The Description of Design Changes on MW503

- Hardware Version : V1.00C
- Software Version : None.

V1.00B

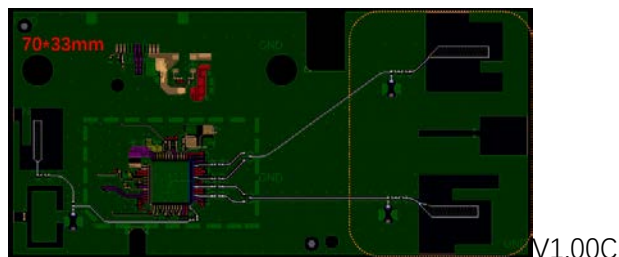
The PCB size of the module MW503 is changed from 55*33mm to 70*33mm, as shown below:

3. PCB on-board antenna design

The Wi-Fi Antenna of the module MW503 is changed from V1.00B to V1.00C, the identification part in the frame as shown above.
